**RE: Anasazi Ridge, Unit 3
Drainage Report, and Grading and Drainage Plan
Engineer's Stamp Date 10-24-2014 (File: A10D002G)**

DRAINAGE REPORT

ANASAZI RIDGE UNIT 3 SUBDIVISION

RE: **Anasazi Ridge, Unit 3**
Drainage Report, and Grading and Drainage Plan
Engineer's Stamp Date 6-19-2014 (File: A10D002G)

FIGURE 1

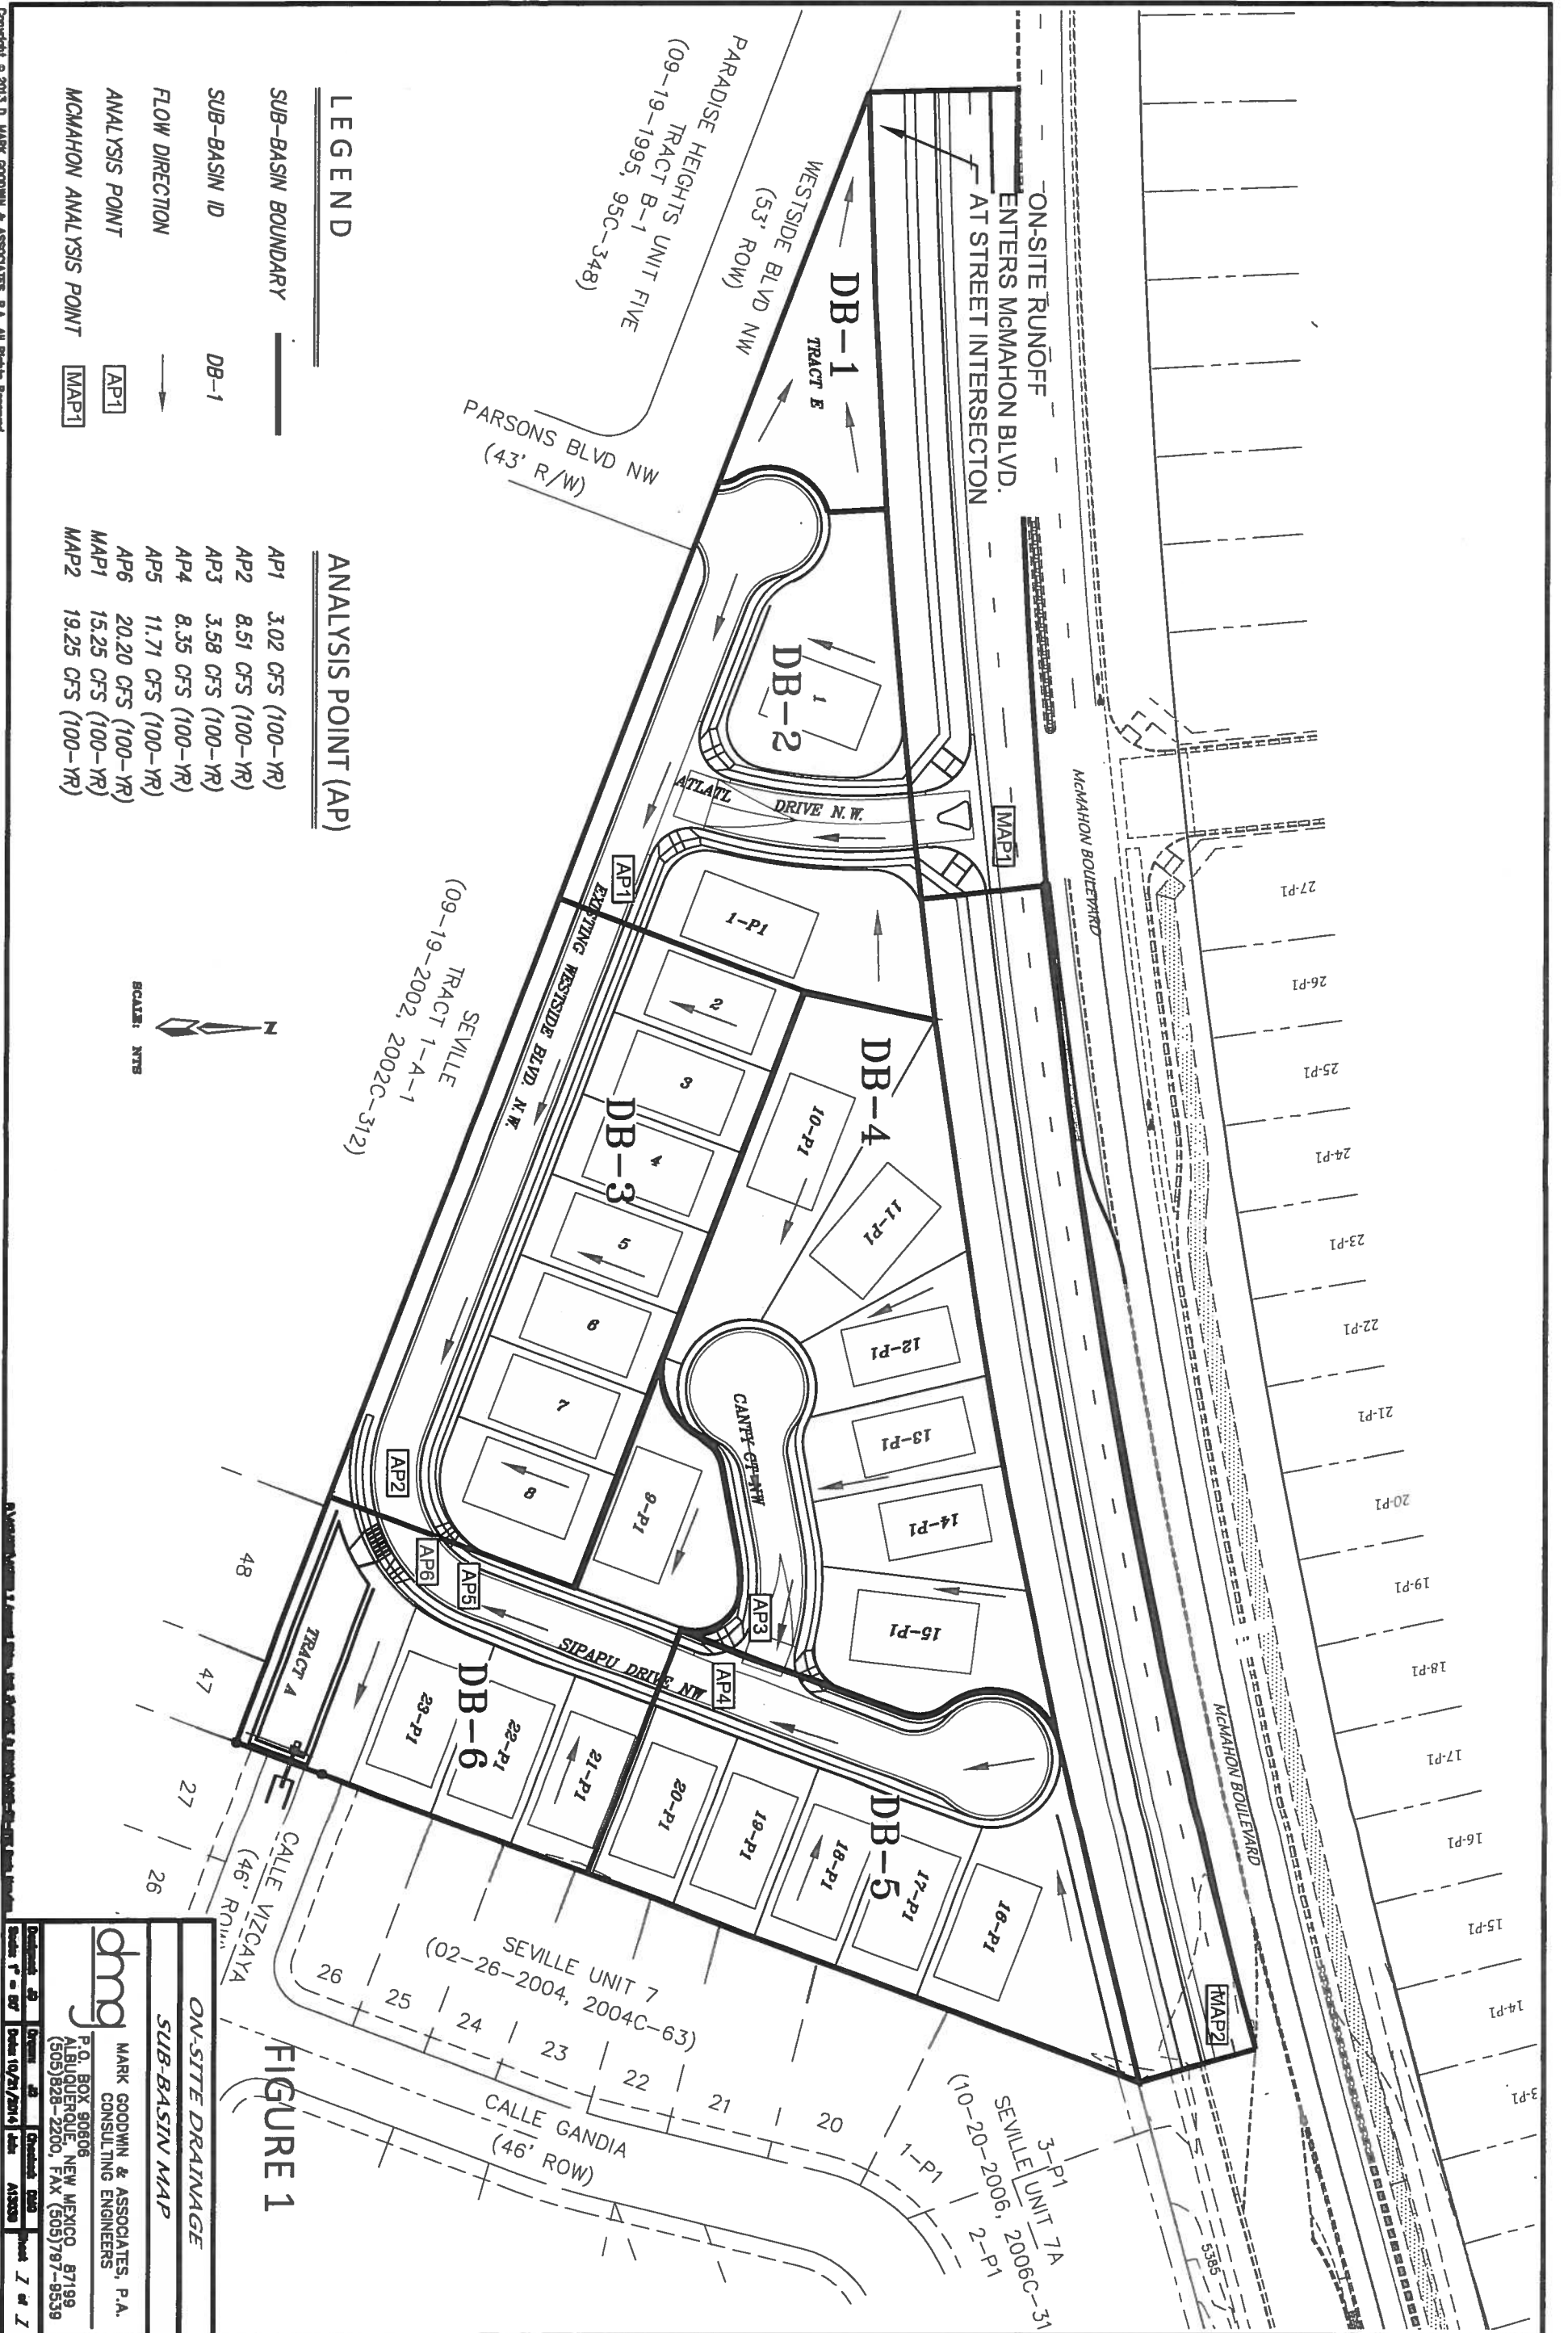
4. Water harvesting pond is upstream from the runoff, and cannot capture first flush. The first flush is intended to capture developed runoff, to comply with EPA requirements.

The majority of the runoff from the project site will be conveyed to the detention pond located at the SE corner. Only DB-1 will outfall to the McMahan. This is due to an awkward parcel shape as well as existing grade ties that won't allow drainage to the east without the use of huge retaining wall that would be both undesirable and economically unfeasible.

B DRAINAGE POND - TYPICAL SECTION
B SCALE: NONE

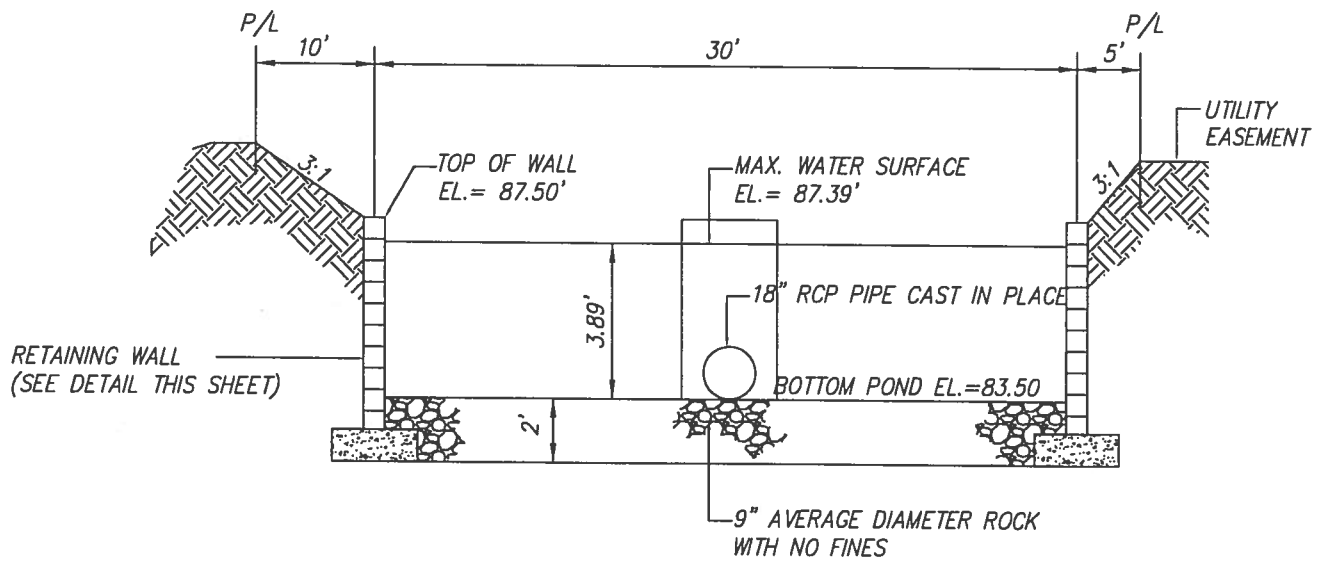
9. Due to the depth, the detention pond appears to need a fence/railing around it. The pond should be called out on the plan and details shown on the plan.

NOTE: 42" HIGH PIPE GUARDRAIL TO BE PLACED ON TOP OF WALL FOR ENTIRE LENGTH.
